Addendum No. 01

Subject: John Marshall Elementary School – Relighting Project
SDP Contract No. B-028 (C) of 2017/18

Location: John Marshall Elementary School
1500 Griscom Street,
Philadelphia, Pennsylvania 19124

DRAWING NO.
ED101

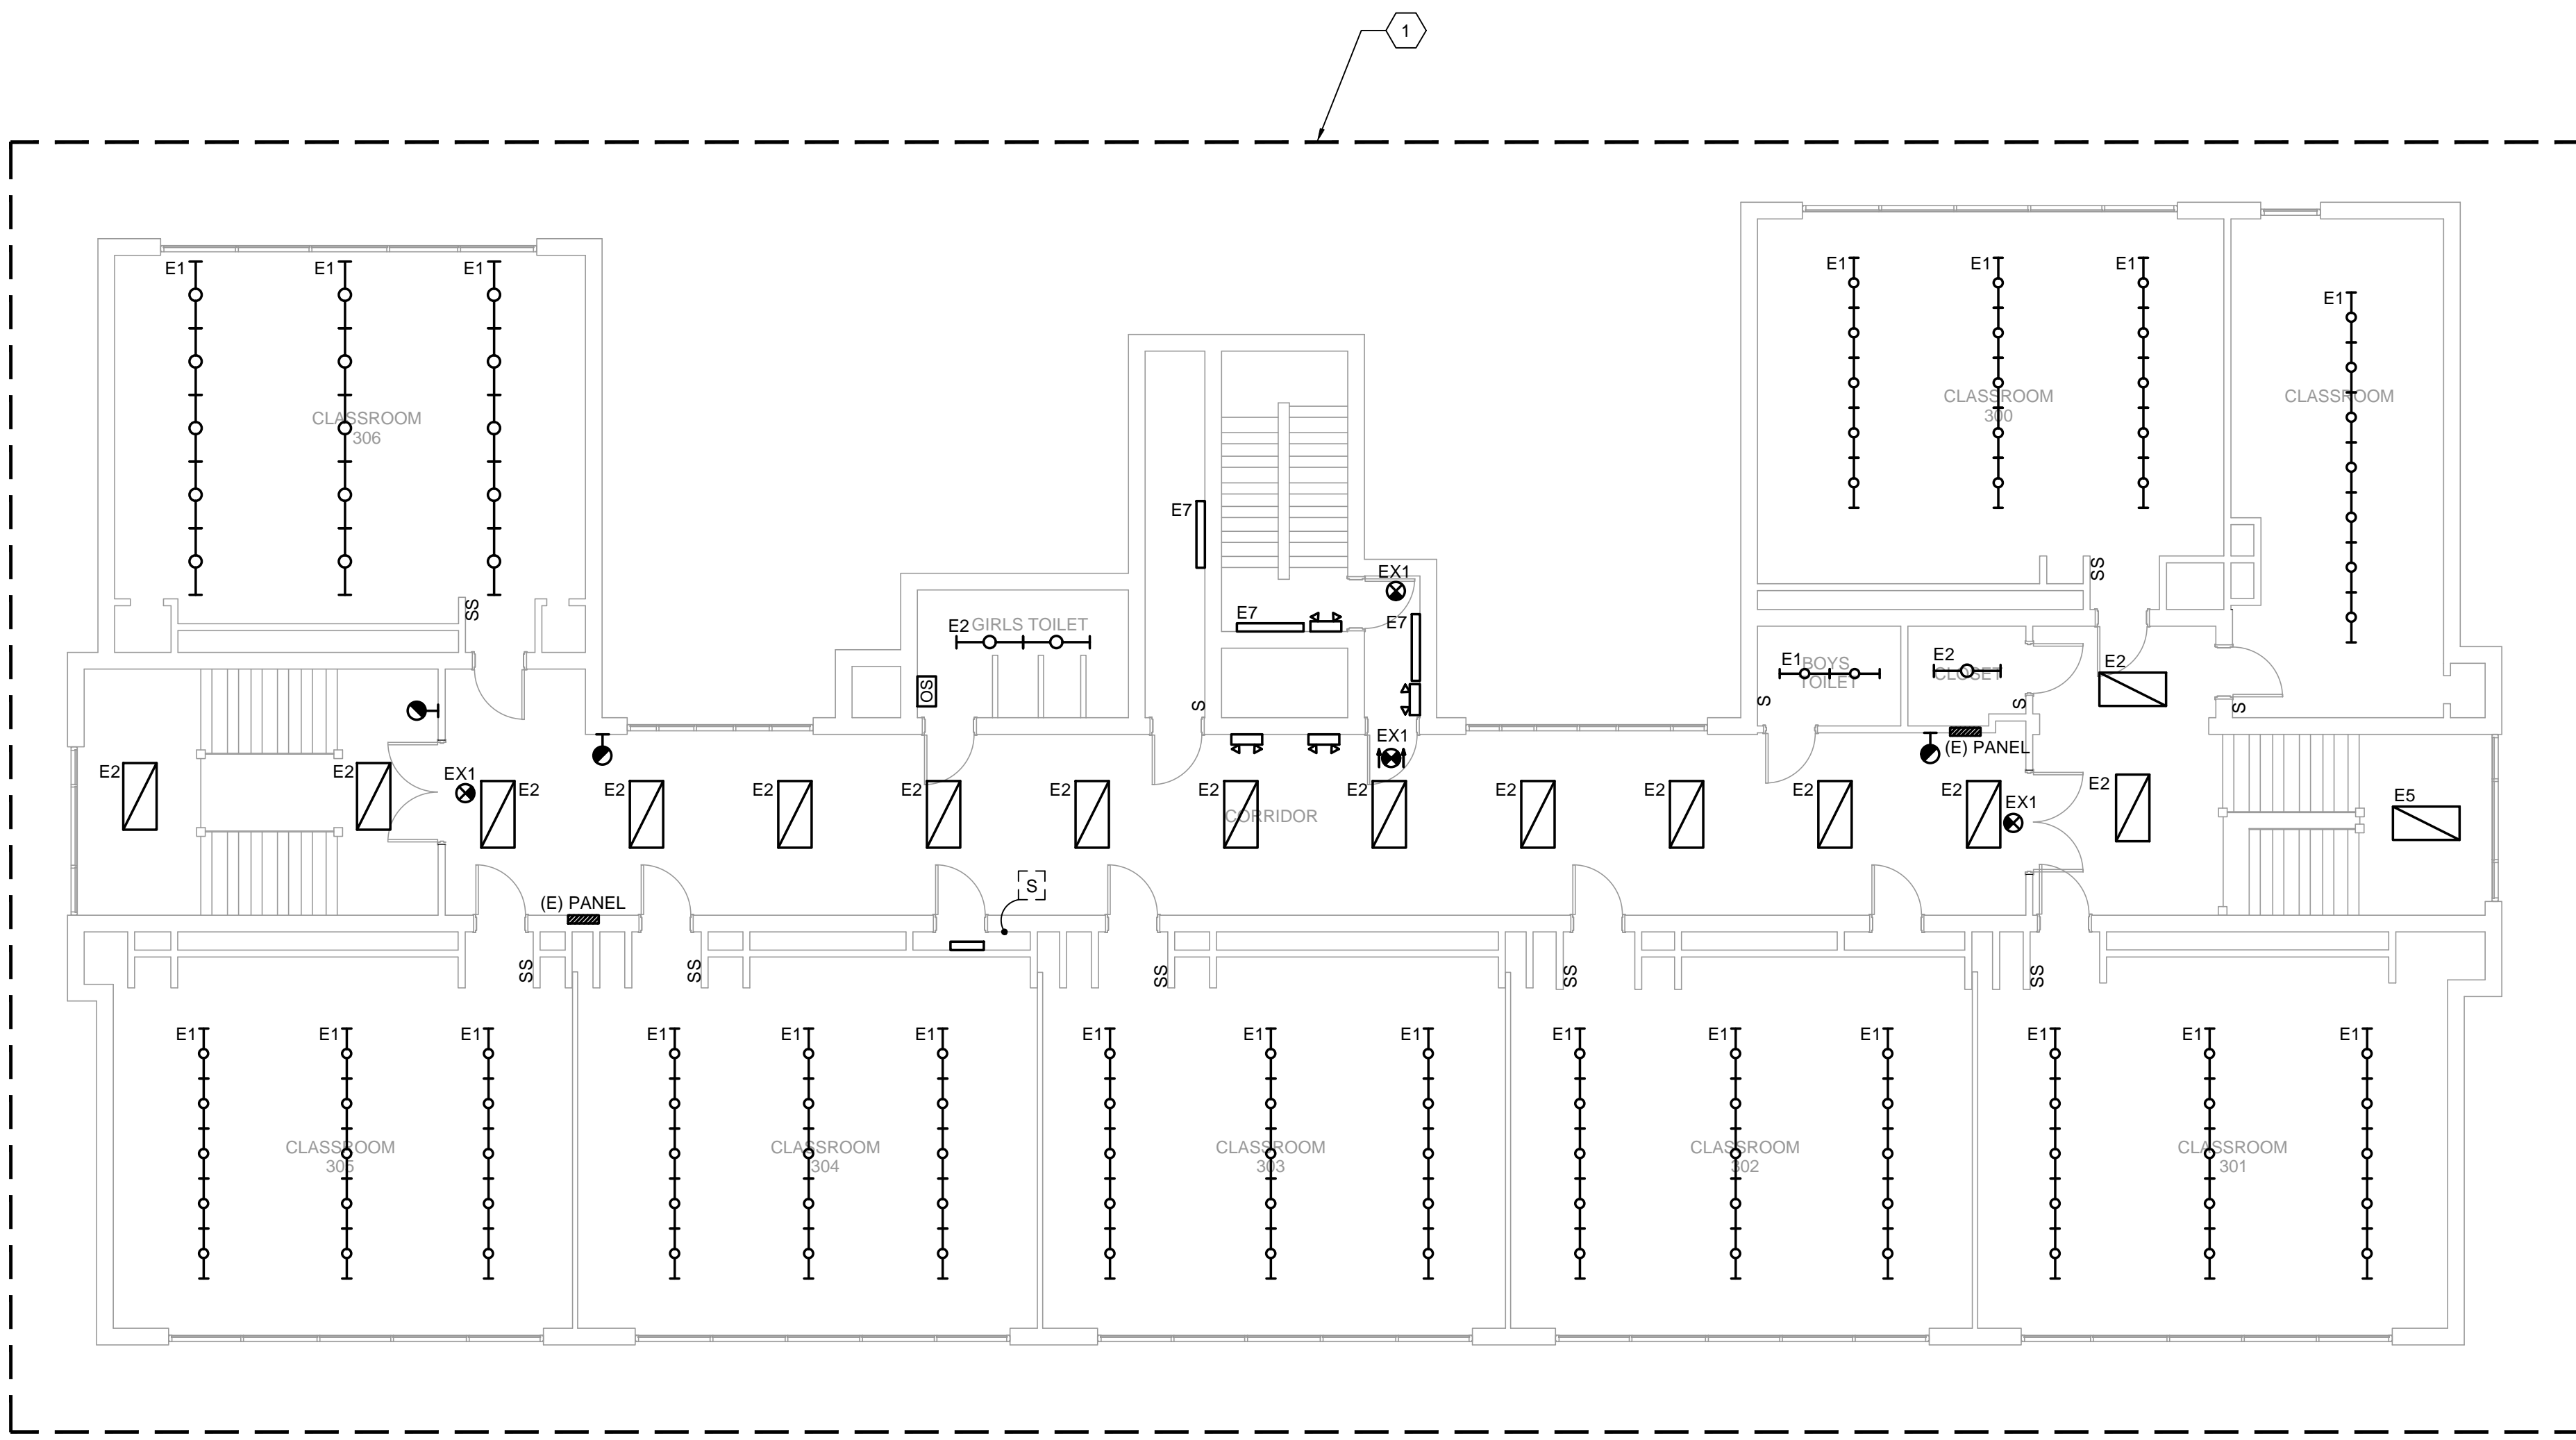
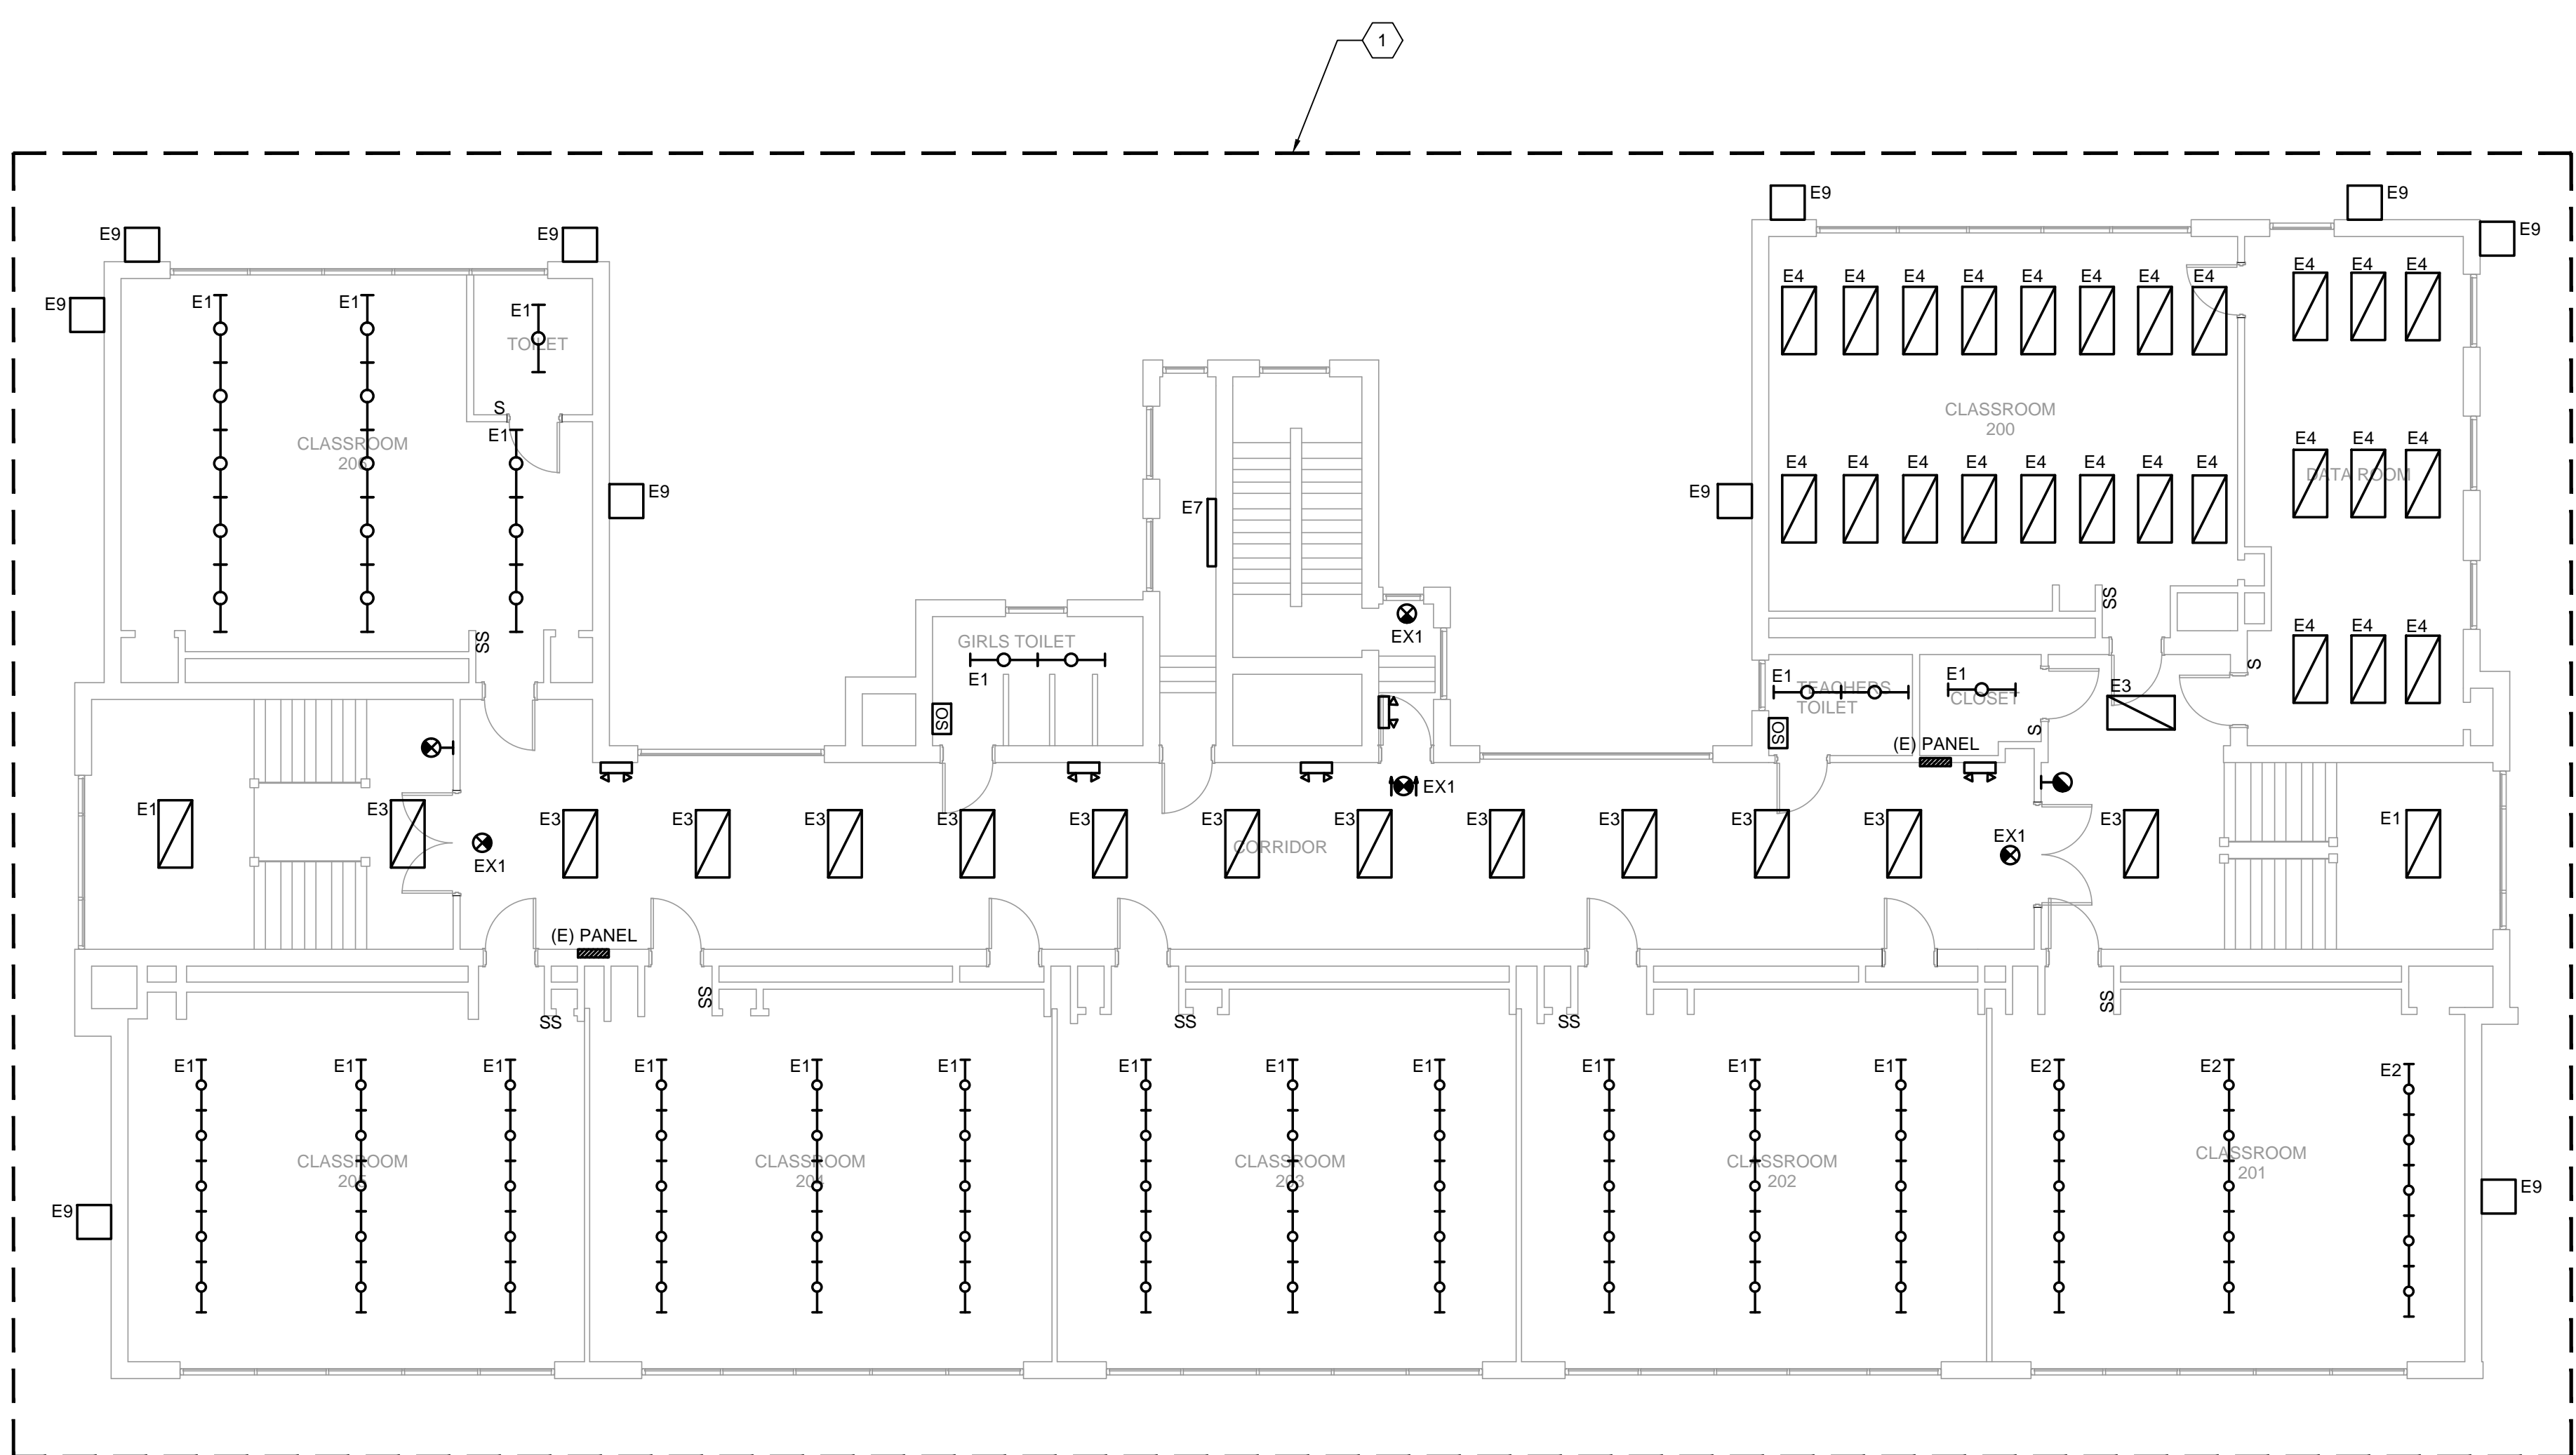
ED100 – Revised Keynote #1.
ED101 – Revised Keynote #1.
E501 – Added detail #5.
E601 – Revised light fixture schedule.

Question#2: Is it clear in drawings that the existing wiremold raceways need to be replaced as part of the re-wiring?

Response – The design intent is as follows: Keynote #1 on the demolition drawings have been updated to indicate removal of all accessible surface mounted raceways which includes any wiremold raceway. As noted on the new work drawings General Note H and Keynote #1, is all new lighting circuiting and controls wiring shall be installed in all new surface mounted EMT conduits and wiring within corridors, classrooms and offices, and rigid steel conduit within boiler rooms, mechanical rooms, and electrical rooms. Existing concealed conduits (EMT and RGS type only) which were previously used for the existing lighting circuiting and controls wiring may be reused if the existing conduit has been field inspected by the contractor and is in good condition for the new lighting circuiting and controls wiring. Existing surface mounted wiremold raceway may not be reused, it must be removed and replaced with new EMT or RGS conduit for wiring.

1 DISCONNECT AND REMOVE ALL LIGHT FIXTURES AND SWITCHING CONTROLS. REMOVE ALL ACCESSIBLE SURFACE MOUNTED RACEWAYS AND WIRING BACK TO SOURCE PANEL BOARD OR NEXT ACTIVE JUNCTION BOX. FOR ALL CONCEALED CONDUIT/WIRING WITHIN WALLS, SLAB, OR CEILING, WIRING SHALL BE REMOVED. CONDUIT SHALL BE CUT AND CAPPED AIR/WATER TIGHT. CONTRACTOR SHALL CIRCUIT TRACE ALL LIGHTING CIRCUITS AND LABEL EXISTING LIGHTING CIRCUIT FOR REUSE FOR NEW LIGHT FIXTURES.

EMERGENCY LIGHT FIXTURE WIRING DIAGRAM
NTS 5

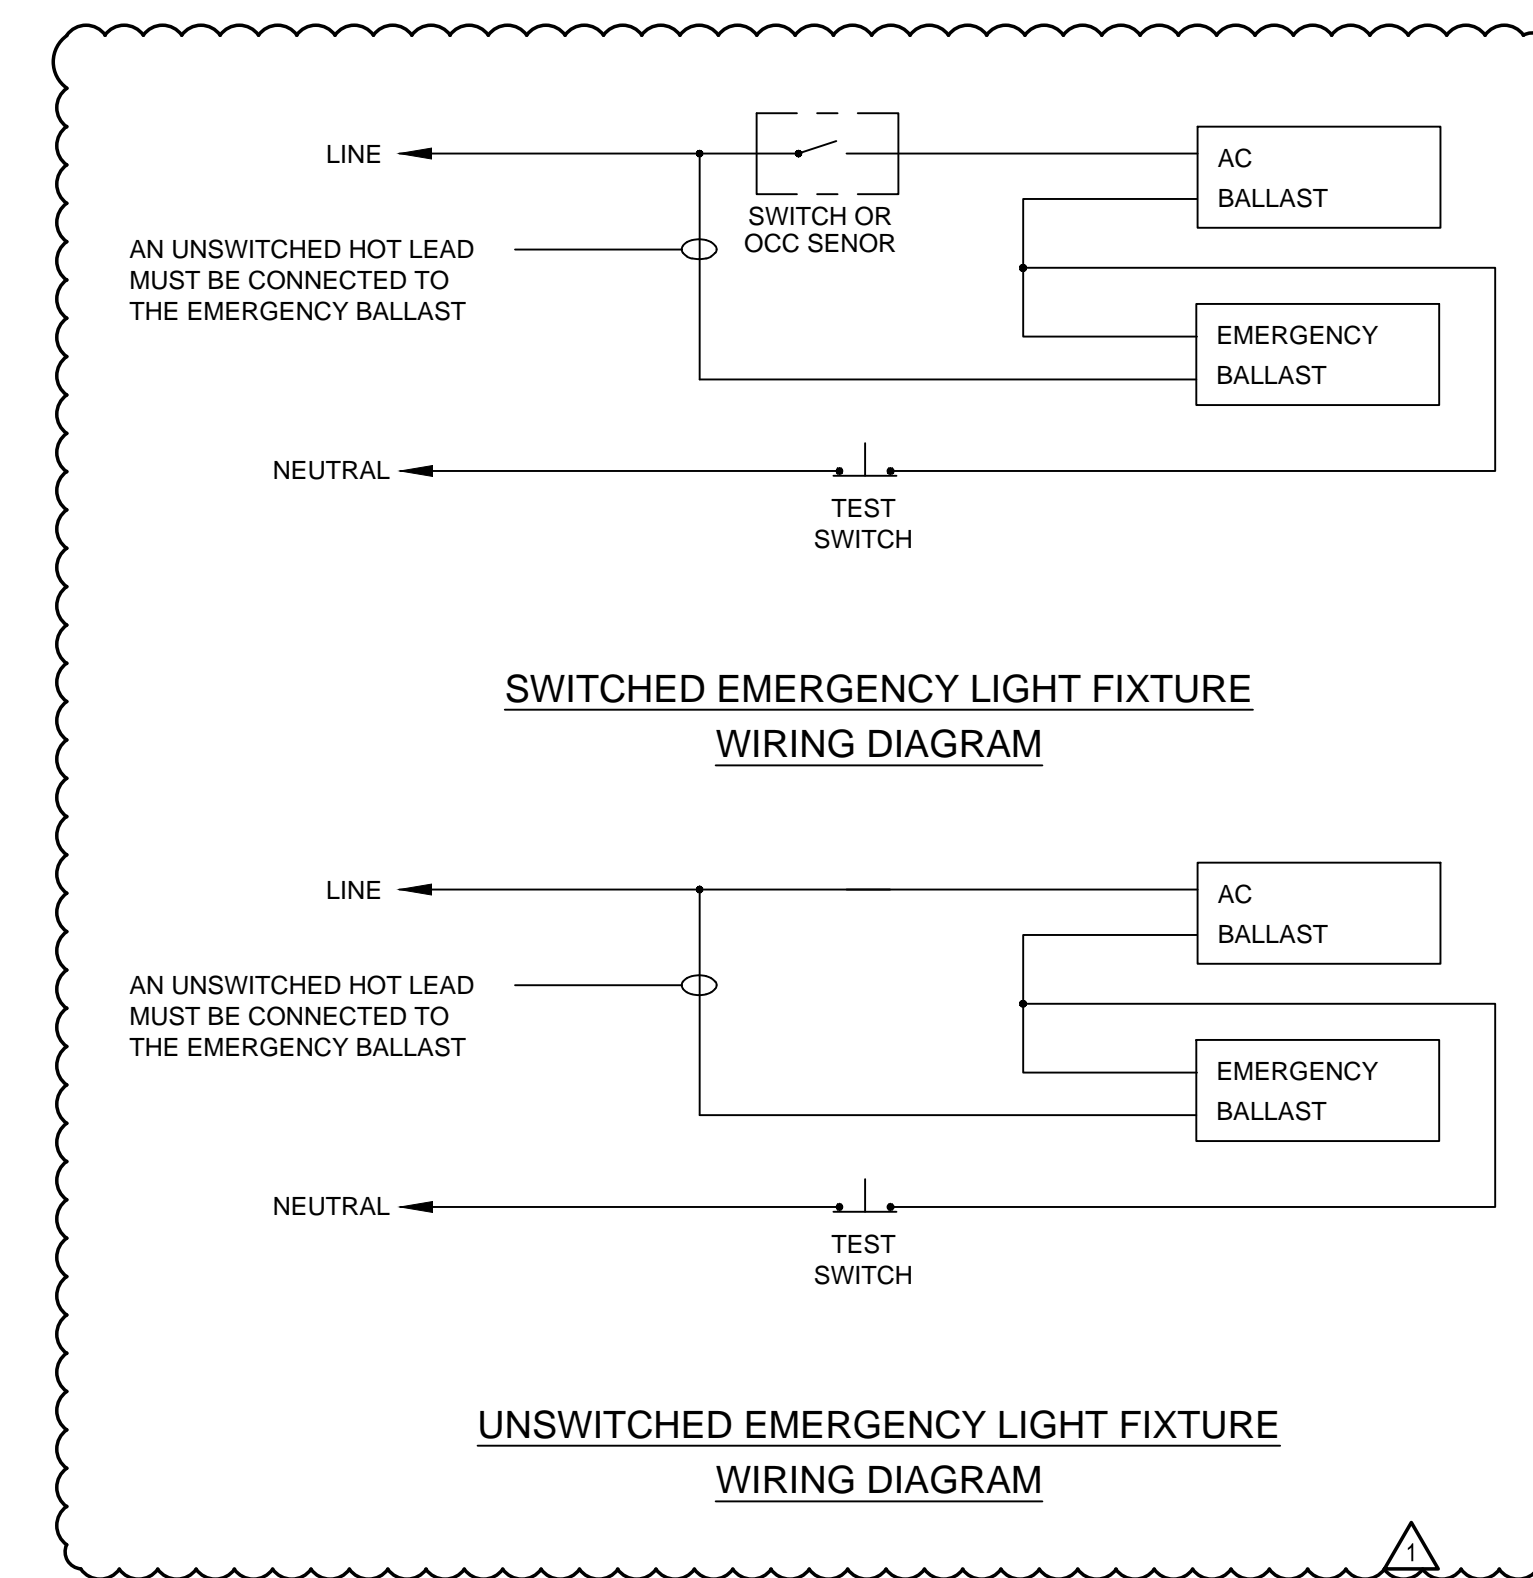
- a. Do we provide new circuit wiring from the existing panels to each classroom? How many circuit to each room?
- b. There seems to be no concealed conduit to existing lights or switches, all wiring seems to be in surface mounted wiremold. Should we bid to replace all wiremold with new conduit and wiring?
- c. Corridor lights are switch on off at night from the breakers in the existing panels. Should we bid to re-wire to existing breakers with additional wiring to feed the new bodine ballast for emergency lights?

Response to Question 3c. – Correct, the existing corridor light fixtures do not have any local switch controls and are turned on/off by the circuit breaker. That is not the design intent for this project, the new corridor light fixtures are to be controls by occupancy sensors. The base design calls for low voltage occupancy sensors to turn on/off all the light fixtures within each corridor, the activation of one sensor shall turn on all light fixtures. In the future, the corridor light fixtures will not be controlled by the circuit breaker, it shall be controlled by the occupancy sensors. The emergency “bodine” battery ballast for each fixture shall be wired to the un-switched side of the local controls within the space to monitor the AC circuit and for continuous battery charging. A typical wiring diagram has been provided on E501.
